Infant-2-Lot Residential Subdivision

CITY OF LAS VEGAS		DATE:
INTER-OFFICE MEMORANDUM		April 24, 2018
TO: Land Development Services Department of Building & Safety		FROM: Albert Sung, P.E. Flood Control Project Engineer Department of Public Works
SUBJECT:	COPIES TO:	
Drainage Study for:	ACG Design	
Infante – 2-Lot Residential Subdivision (Project in Clark County for City of Las Vegas Concurrence)		
Cross Streets:	SWC of Jensen Street & La Madre Way	Angelo Infante
File Number:	F:\Depot\DSMemos\DS4977A.doc	Bart Anderson, P.E., DevCo
Parcel Number:	125-31-401-004	CCPW
Zoning Action:	N/A	
FEMA Flood Zone	YES	NO X
Proposed Storm Drain	YES	NO X

The Drainage Study for the subject project has been reviewed and:

City of Las Vegas Flood Control staff has reviewed the Technical Drainage Study for the subject development "**Infante – 2-Lot Residential Subdivision**" within the jurisdiction of **Clark County**. **City of Las Vegas** concurs with the acceptance of the drainage study by the **Clark County Public Works Department**. The review of this project was limited to issues of flood control significance to the **City of Las Vegas**.

CROSS SECTIONS & DETAILS SHEET

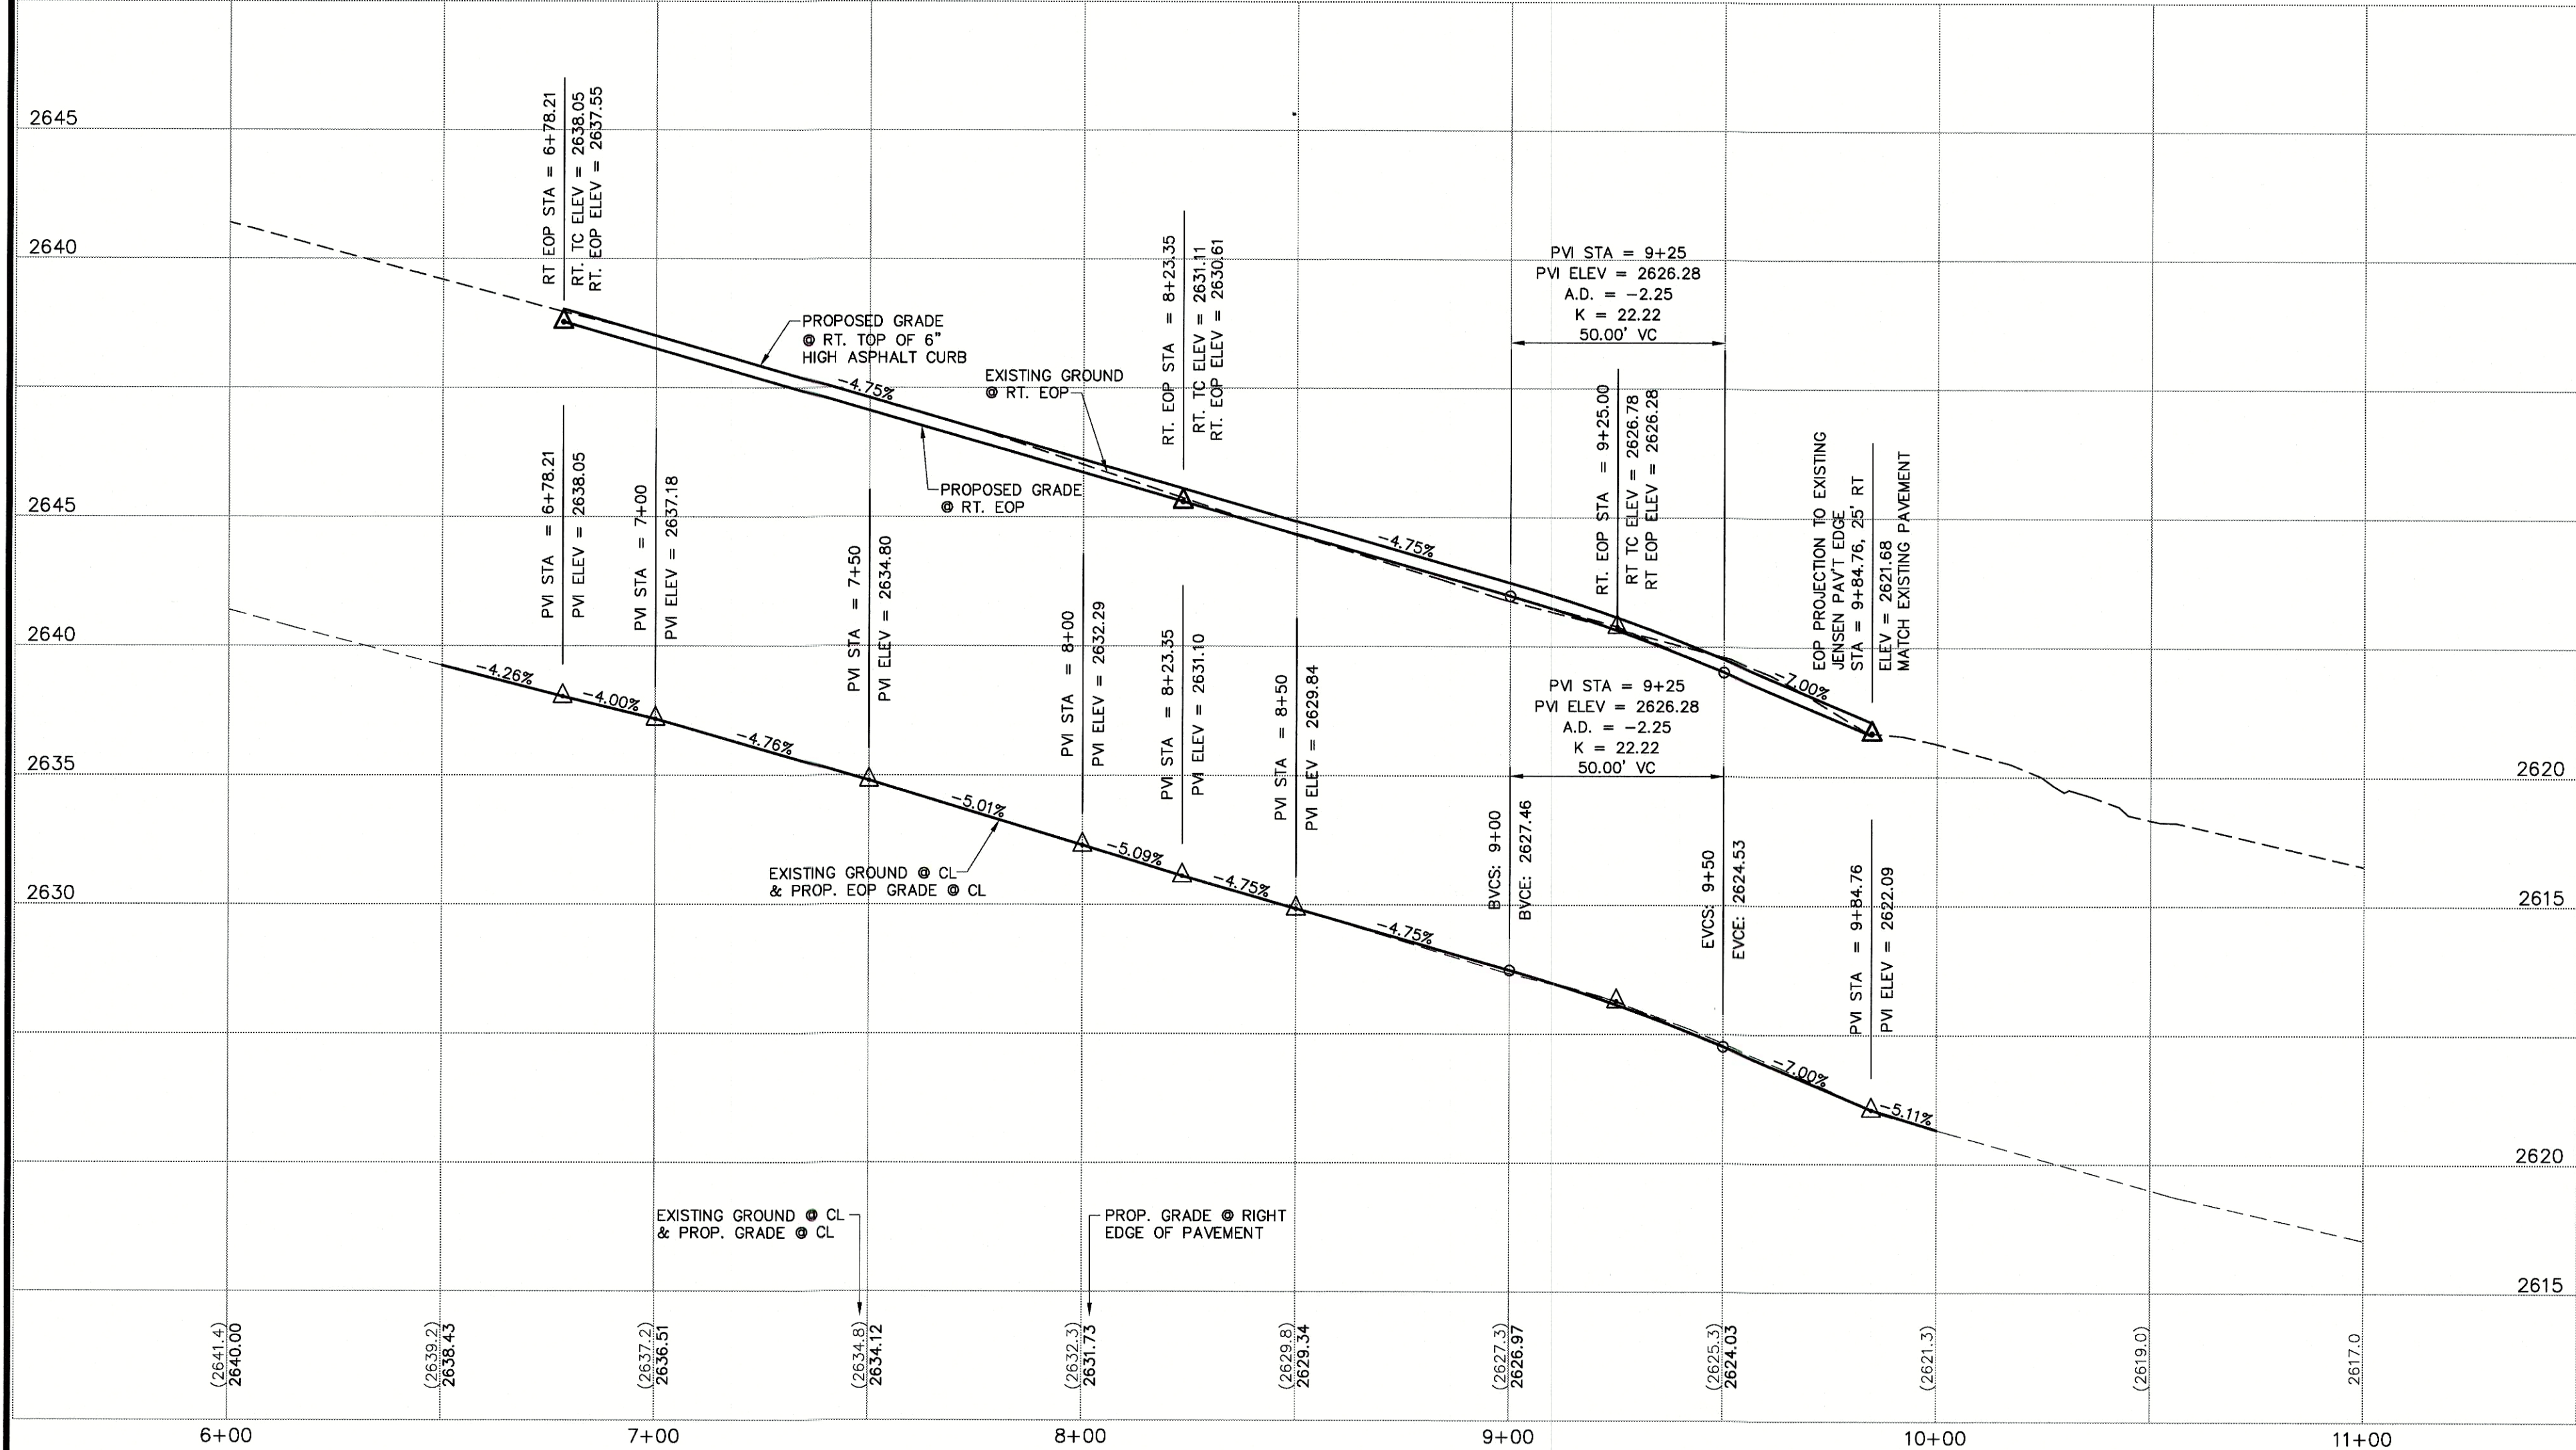
I just got off the phone with CC. They allow the asphalt curb when they don't have all the right of way they need for an overpave. In this case the right of way is out of their jurisdiction and owned by BLM. Based on this I think we are okay with the design. Let me know if you need anything else.
